Office Action Summary

10/803,005

ELLINGSON, ROBERT T.

DETAILED ACTION

Figure 2 from Young

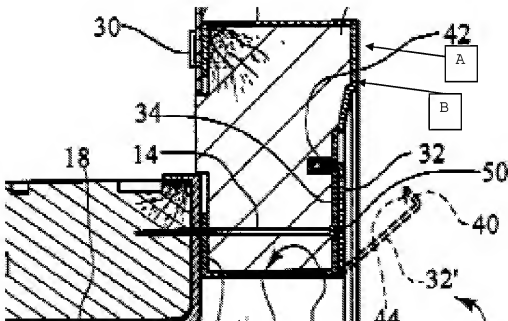
Claim 1: Young discloses a frame comprising a sill, a pair of spaced side jambs and a head jamb spanning the side jambs and a unitary plastic member (see Fig. 2: 20) attached to the head jamb, the plastic member configured to define a flashing strip (24) overlying and covering an upwardly facing top surface of the head jamb to inhibit moisture contact with the head jamb, a nailing fin (proximate 28: it is unitary in that 28 is attached to portion 20 via 30) projecting upwardly from the flashing strip and away from the head jamb to attach the frame to an adjacent structure with fasteners extending through the nailing fin (see slots on the fin) and a drip edge (see "A" from

attached Fig. 2 from Young, below) extending along an upper outside corner of the head jamb to direct water from the flashing strip away from the head jamb. In case the applicant disputes the definition of "unitary plastic member", it would have been obvious at the time the invention was made to a person having ordinary skill in the art to make the piece a single member because as shown in the drawings portion 28 and 24 are connected via a staple, so therefore making the piece a single piece is within the level of skill in the art in order to, for example, aid in the ease of manufacture in reducing processing steps.

Claims 2 and 16: the nailing fin is attached to the flashing strip with a flexible hinge (the juncture between portions 24 and 28 form a flexible hinge via member 30.)

Claim 3: the drip edge includes a lip ("B" above).

Claim 12: A drip edge ("A" above) formed along the flashing strip.
